## CLARENDON BLVD. FROM N. COURTHOUSE RD. TO N. SCOTT ST.

SCALE: 1"=25'

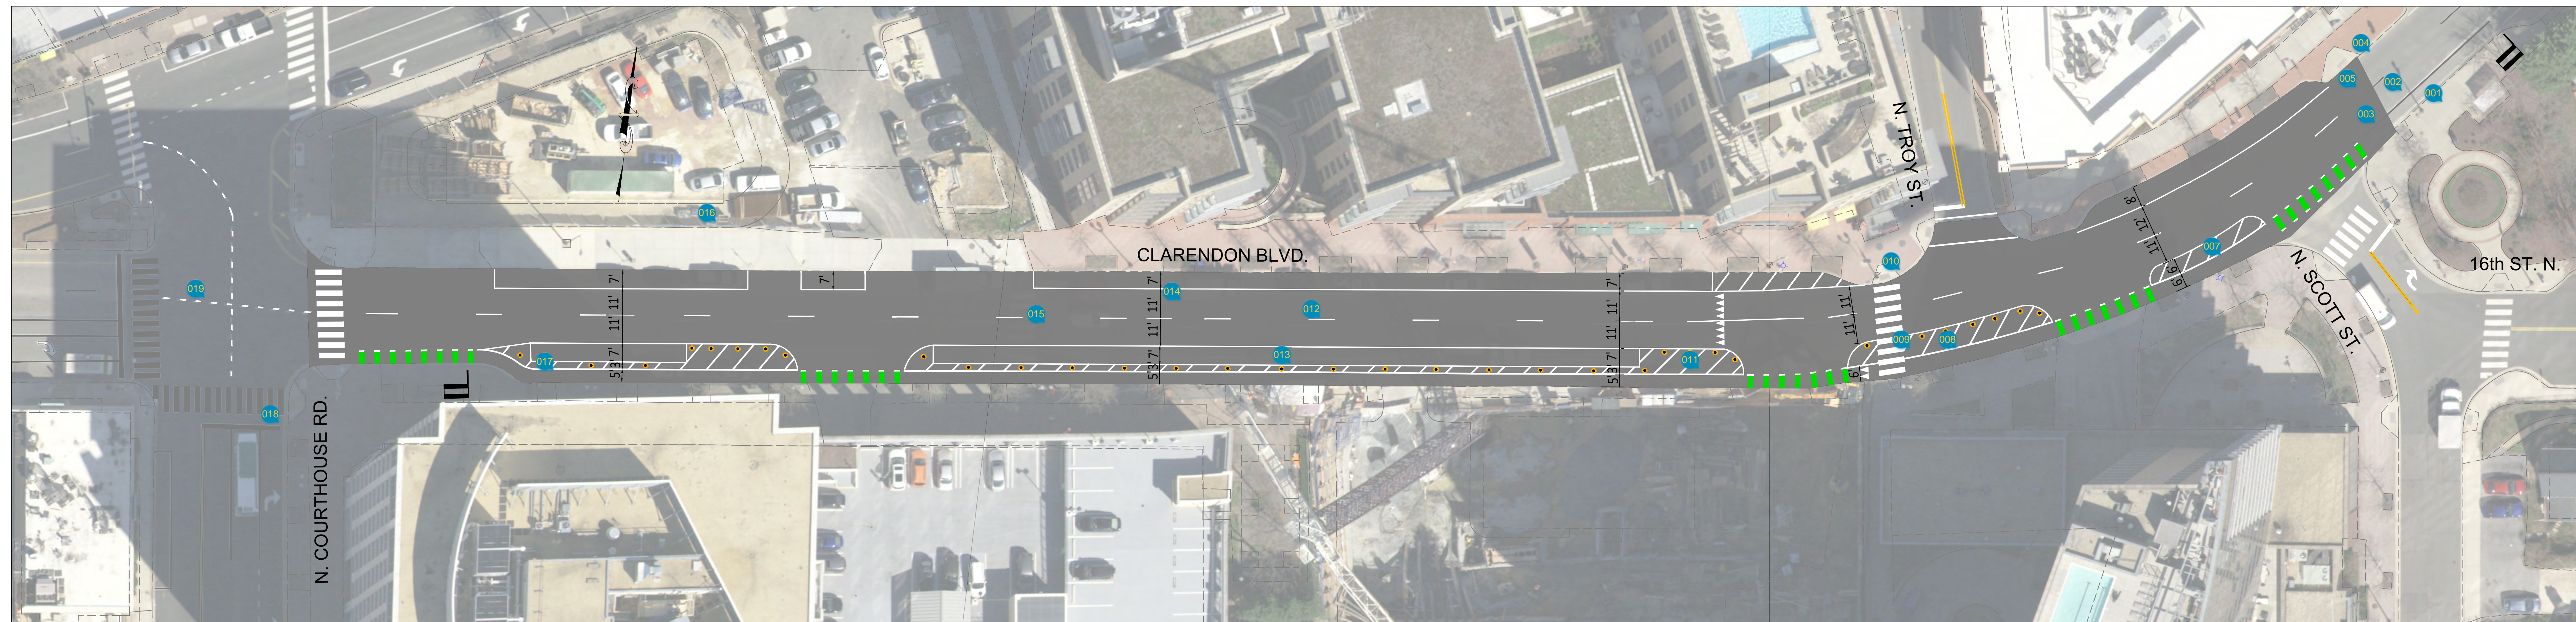
Type: Question  
Agree: 2, Disagree: 0  
1) What about the bicycle lane transition between N. Scott and N. Rhodes? Why not also re-do this short stretch to be consistent and avoid merging cycles in traffic?  
2) PLEASE put direction markings on the bicycle lanes. Cyclists and scooters use these against the direction of traffic and cause issues daily.

Type: Suggestion  
Agree: 5, Disagree: 0  
There should be a crosswalk here. Many people jump into the street from the large apartment building entrance / yoga studio to the rock garden / sushi rock side and vice versa. It is an almost blind downhill where car trucks and buses are speeding. With the kids and teenagers getting out of school and walking around it is treacherous. There also needs to be a speed sign that lights up and shows your speed. The speeding is egregious.

Type: Suggestion  
Agree: 0, Disagree: 0  
This is a natural spot for a crosswalk. The curb cuts are already in place and it may be safer than the one above, which is just over a hill. Please consider.

Type: Suggestion  
Agree: 1, Disagree: 0  
This is a dangerous bump out that is located on a vertical and horizontal curve. Vehicles frequently stop at the bump out to load/unload/park. It is a safety issue. Please consider removing this bump out.

Type: Suggestion  
Agree: 5, Disagree: 0  
Personally I don't think this is a good spot for a crosswalk because the curve nature of the road will create blind spot for driving coming down the hill.

Agree: 0, Disagree: 0  
There appears to be some missing flexposts here.

Agree: 0, Disagree: 0  
Please add some bike racks to this space to prevent illegal parking

Type: Suggestion  
Agree: 5, Disagree: 0  
Similar issue with the cars trucks and buses speeding down this blind downhill, no speed accountability. With the curve of the road and people trying to parallel park it is a truly dangerous intersection. Walking to Ace hardware from the other side of Clarendon with a toddler and or a stroller is treacherous. When someone stops for a pedestrian, the car behind usually honks and swerves around them, while speeding up, not knowing that car was yielding to a person in the crosswalk. Enhanced markings will not help. The pavement needs to be lit and flash at a minimum, and a speed sign that shows "your speed". Otherwise, a sign to "stop when pedestrians are present" would be the best option. That and pull over the vehicles that are speeding. The dangerous speeding is Arlington buses and constructions vehicles just as much as cars.

Type: Suggestion  
Agree: 1, Disagree: 0  
Agreed, this is an awful place to cross. You either have to walk up the hill to cross at the Courthouse Rd light, or brave being hit. I would love to see traffic calming measures like a speed bump or something to prevent people from racing down. Speed limit is 25 and people are always trying to go 35+, adding lights will do nothing.

Type: Suggestion  
Agree: 2, Disagree: 0  
Agree with another comment that this requires a physical traffic calming measure - weather a speed hump or island - to actually force reduction of downhill momentum. Paint doesn't protect.

Type: Suggestion  
Agree: 1, Disagree: 0  
I agree with the other comments that this location feels incredibly dangerous as a pedestrian, due to poor uphill sight lines and cars gaining momentum downhill. The fact that this is a two-lane one-way street makes it worse. Something unusual/radical should be done here that might not be considered elsewhere.

Obviously we cannot put speed humps on an arterial street, and there may not be a warrant for a signalized intersection. A pedestrian-activated crossing make make it even less safe if cars can't see it in time to stop. It would need to have an overhead component to be properly effective.

My suggestion for consideration is to create a mid-street island like was just added on Barton at Fairfax. Both as traffic calming and to provide a refuge.

Type: Suggestion  
Agree: 0, Disagree: 0  
Very few drivers actually stop to let pedestrians cross. I always feel like I will get hit trying to cross this intersection. I think a pedestrian activated lights to alert drivers would help but that will need to be put further up on the road. Maybe not speed bumps like you mentioned but rumble strips (alert strips) might work as long as it doesn't create loud noises for residents nearby.

Type: Suggestion  
Agree: 1, Disagree: 0  
This crosswalk definitely feels dangerous and cars rarely stop for pedestrians. Perhaps a raised crosswalk could help with the vehicle speed.

Type: Suggestion  
Agree: 7, Disagree: 0  
Need to ensure no parking is strictly enforce here. People tend to park illegally to go to ACE hardware or 7-11 and it always obstruct the view for residents leaving the garage to safely merge into Clarendon Blvd.

Type: Suggestion  
Agree: 8, Disagree: 0  
Where possible these bollards should be hard bollards, not flexiposts. As we regularly see on Veitch, flexiposts are very easily knocked down and hard to maintain and the lack on consequences to drivers who hit them encourages a culture of reckless driving

Type: Suggestion  
Agree: 2, Disagree: 0  
Fully agree that these bollards should not be flexible. The only person a flexible bollard helps is a driver breaking the law. Cyclists and sidewalk users deserve real protection.

Type: Suggestion  
Agree: 5, Disagree: 0  
County should enforce parking within lanes. Traveling through Clarendon Blvd and Wilson Blvd on certain segments are difficult because a lot of drivers park their car outside the lanes into the road, causing cars who are traveling on the road have to constantly change lanes to avoid hitting parked cars.

Type: Suggestion  
Agree: 6, Disagree: 0  
Agreed. Also, Arlington County should mark parking for each individual space instead of just one giant box across the entire road. Parking is already difficult around the area and lots of people don't know how to park properly. People like taking up way too much space because they are inconsiderate of others who are also trying to find a parking spot

Type: Suggestion  
Agree: 0, Disagree: 0  
Perhaps putting a (highly visible) crosswalk further uphill would mitigate some of the safety issues mentioned by others around the Troy St intersection. Also, with the new Wendy's development coming in, the volume of pedestrian traffic is likely to increase in coming years.

Type: Suggestion  
Agree: 2, Disagree: -1  
This might be a little far/unpopular, but I honestly feel like all of Clarendon Blvd. should just be one lane in the Clarendon to Courthouse areas. There's not really a ton of traffic all the time but there are a ton of pedestrians. It's pretty stressful to drive here with people walking out in to the street all the time. This would also give people more of a buffer to park their cars without fear of being sideswiped by passing cars as others have mentioned. Not to mention the bike lanes, etc.

Type: Suggestion  
Agree: 3, Disagree: 0  
Paint is not protection. There should be protected bike lanes everywhere and in all projects in Arlington. We shouldn't have to fight for this.

Type: Suggestion  
Agree: 1, Disagree: -1  
The parking lanes are too narrow. Vehicles frequently encroach on the travel lanes causing safety issues such as side swipes and rear ends. The bike lane should be narrowed to 5 ft (NACTO recommended minimum is 4 ft) so that the parking lanes could be made wider.

Type: Suggestion  
Agree: 1, Disagree: -1  
\*bike lane should be narrowed to 4 ft

Type: Suggestion  
Agree: 1, Disagree: 0  
Agreed that Vehicles frequently encroach on the travel lanes. This is a big issue throughout Clarendon and Wilson Blvd. I constantly have to change lanes just to avoid hitting parked cars.

Type: Suggestion  
Agree: 5, Disagree: 0  
Lots of people don't read the "no turn on red" sign. It definitely needs a larger sign than the current one. I personally see people turning on red on a daily basis. In addition, pedestrians always seem to cross when the right turn green arrow is on for cars.

Agree: 2, Disagree: 0  
Agree with this person. I walk through this intersection every day and it seems like only a quarter of drivers actually listen to the "no turn on red" sign. I don't think the sign is working. I think pushing back the intersection line a few feet so that cars don't pull right up to the corner of the intersection would do a lot for pedestrian safety
